SCHWEIZER SERVICE NOTICE

NOTICE NO. N-224

SUBJECT: INSPECTION AND POSSIBLE REPLACEMENT OF 33-199-915 FUEL FILTER ELEMENT (WIRE MESH SCREEN WITHOUT STIFFENERS).

MODELS AFFECTED: All Model 269A, TH-55A, 269A-1, and 269B Series Helicopters.
Model 269C Helicopters having Serial Numbers prior to 1313.

FIGURE 1. FUEL FILTER STRAINER - EXPLODED VIEW.

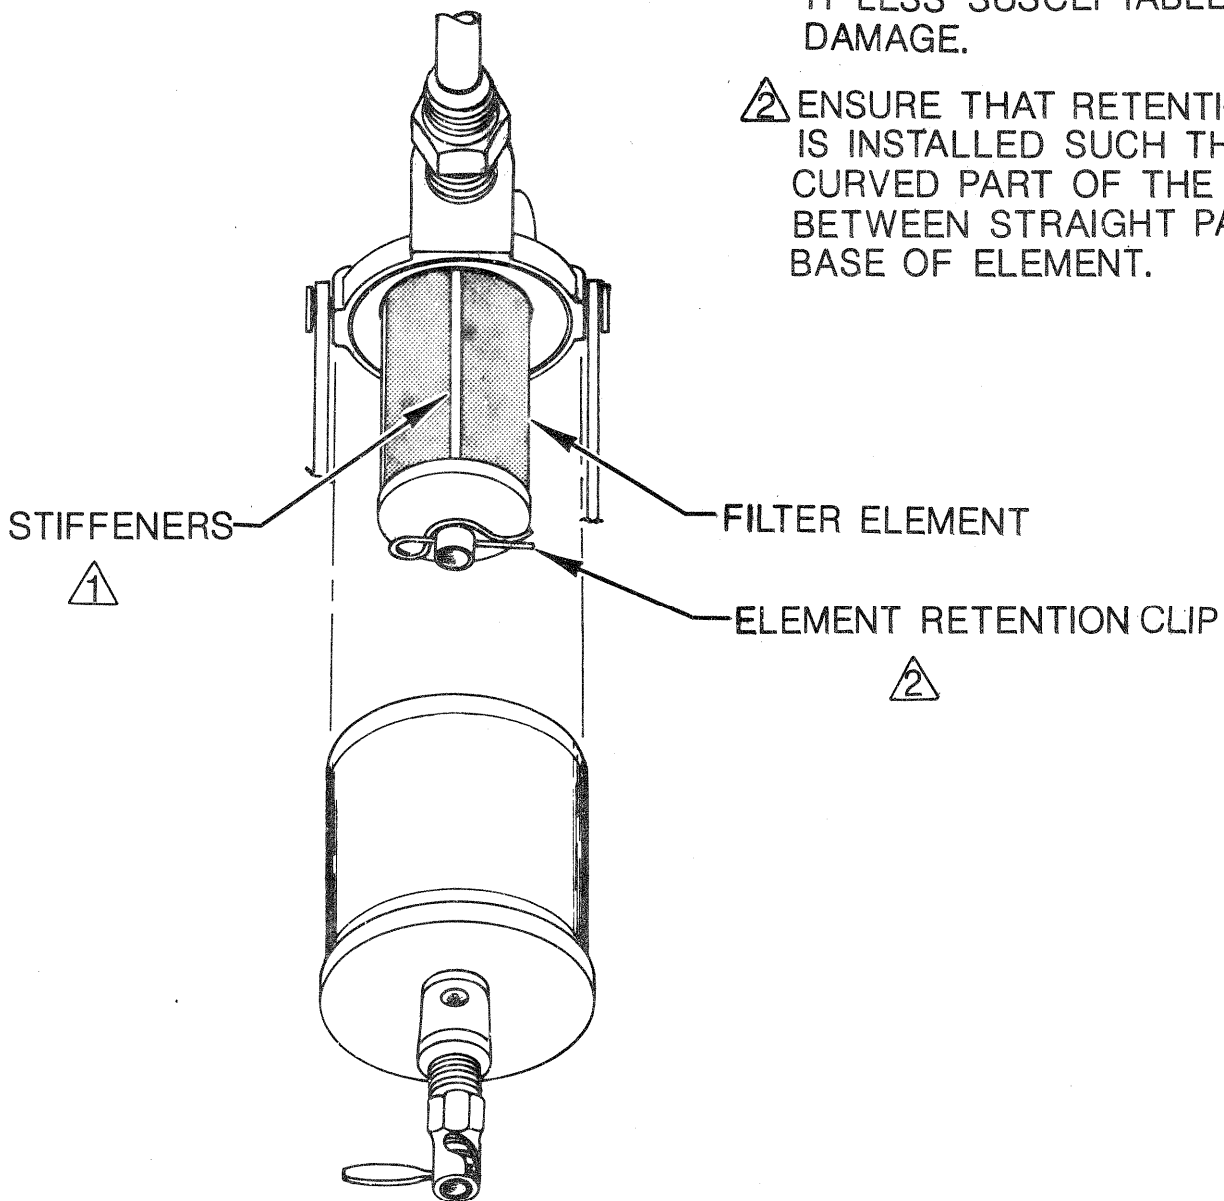
- c. Visually inspect filter element for damage and distortion as specified on the attached SIGMA-TEK Service Letter No. 007.
- d. If any damage or distortion of the filter element is observed during the inspection, remove the filter element and replace it with the current 33-199-915 element which incorporates stiffeners. (Refer to Figure 1.)

As shown in Figure 1, the clip which secures the filter element in the stainer must be installed such that the curved part of the clip is between the straight part (of the clip) and the base of the element. If clip is installed in opposite manner, the element may slide down in the strainer and allow unfiltered fuel to enter the engine fuel system.

① CURRENT ELEMENT INCORPORATES STIFFENERS TO MAKE IT LESS SUSCEPTABLE TO DAMAGE.

② ENSURE THAT RETENTION CLIP IS INSTALLED SUCH THAT THE CURVED PART OF THE CLIP IS BETWEEN STRAIGHT PART AND BASE OF ELEMENT.

- e. Ensure that element retention clip is installed in proper manner as shown in Figure 1.
- f. Reassemble filter stainer in accordance with Basic HMI, paragraph 5-47; open FUEL SHUTOFF valve.
- g. Record compliance with this Service Information Notice in Compliance Record of Helicopter Log Book.

SIGMA TEK FUEL STRAINERS P/N G199-105-5D
SIGMA TEK FILTER ASSEMBLY P/N 33-199-915

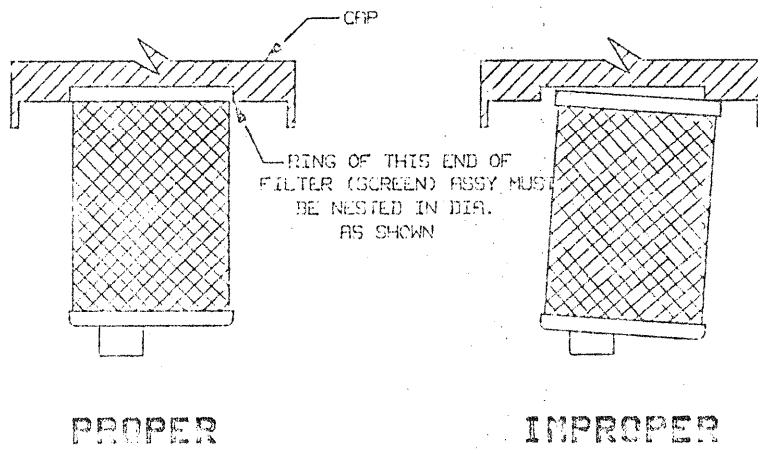
The Fuel Strainers should be checked to assure that the Filter Assembly is nested in its proper installed diameter in the strainer cap and that the filter is not damaged. See sketch below.

The Filter Assembly should be inspected for damage due to improper installation, handling, or shipping damage, such as: being twisted, distorted, collapsed, or torn.

The current Filter Assembly, P/N 33-199-915, is manufactured with stiffeners which make it less susceptible to damage. These are available through the Sigma Tek Parts Sales Department. Unused G199-105-5D Fuel Strainers and unused 33-199-915 Filter Assemblies may be returned for exchange.
